CALIFORNIA COASTAL COMMISSION

A-2-SMC-19-0002 (Zubieta SFD)

CORRESPONDENCE

subject Arbor Lane Coastal Bluff Erosion Review and Study (ESA Ref. #D191384.00)

Figure 3
USGS CoSMoS erosion hazards with 4.1 feet of sea-level rise:
"Hold the Line" scenario

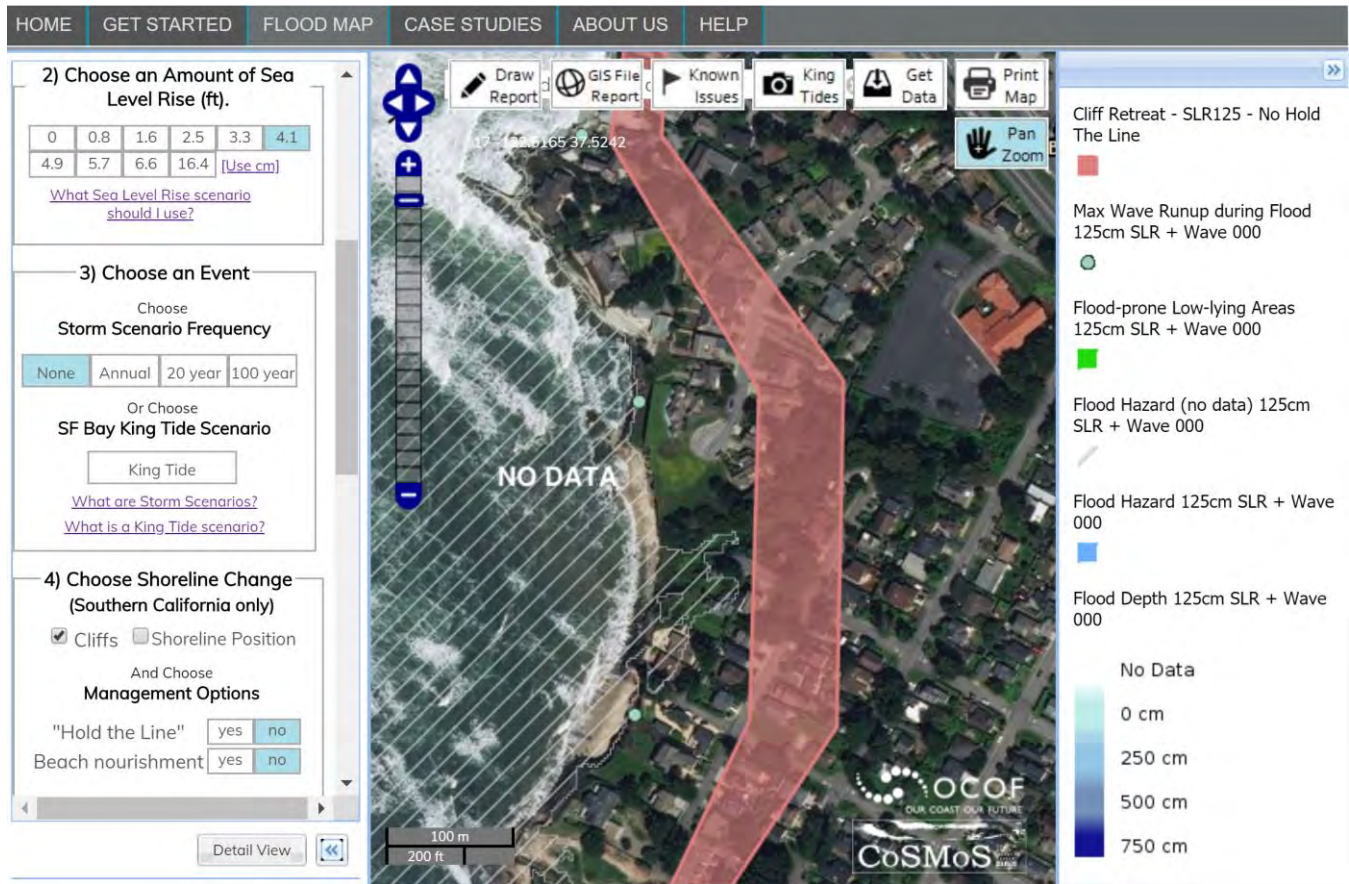
Note that the GSI (2019) study reports erosion projections by the USGS's Coastal Storm Modeling System (CoSMoS) for "hold the line" scenario only, in which areas with existing coastal armoring do not erode in the future (Figure 3). GSI (2019) does not describe the results for the scenario where erosion is allowed, which is presented in Figure 4. Note that the project site is located between two transects and so erosion at the site is computed as an interpolation between these points: the transect to the north is located at an existing coastal armor structure and the transect to the south is at an unarmored location. Although the USGS hazard mapping is a coarse and regional approach to assessing the coastal response to sea-level rise, the results provide an independent assessment produced by a credible federal agency.
